Field campaign

Topic	Power Assisted Steering - Pipe Union - Incorrect Dimensions (RE19/27)
Market area	Bentley: worldwide (2WBE),Hongkong-Macau (5HK)
Brand	Bentley
Transaction No.	2057135/1
Campaign number	RB41
Note	
Type	Recall Campaign
US code

Supersport - Supersport Convertible - Continental 24

Figure 1

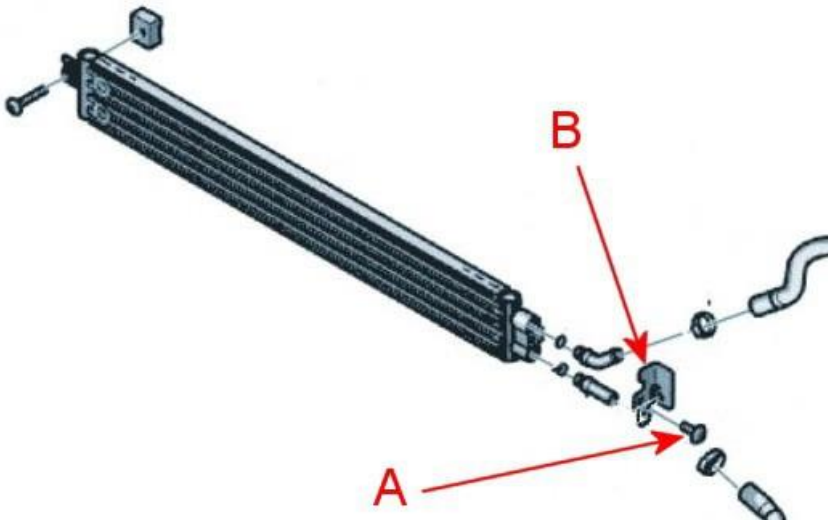
Remove and discard the socket head screw "A" (N907.371.05) from the PAS fluid cooler, remove securing bracket "B", note the position and orientation of the retaining bracket and stub pipes prior to removal – figure 1.

Refit the retaining bracket “B” to the PAS fluid cooler using new socket head screw “A” (N907.371.05) (5 Nm) – figure 1.

Figure 2

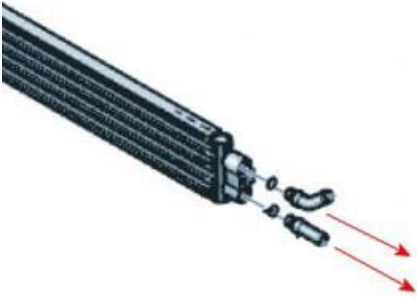
Remove and discard the two PAS cooler stub pipes, the stub pipes should be withdrawn from the PAS cooler body – figure 2.

Note – Take care not to damage the cooler matrix.

Noting the original stub pipe position and orientation fit new PAS fluid cooler stub pipes 3W0.422.890 – Pipe union lower and 3W0.422.890A – Pipe union upper, lubricate the o-rings fitted to the stub pipes with new Pentosin hydraulic fluid (Pentosin CHF 11S) when fitting – figure 3
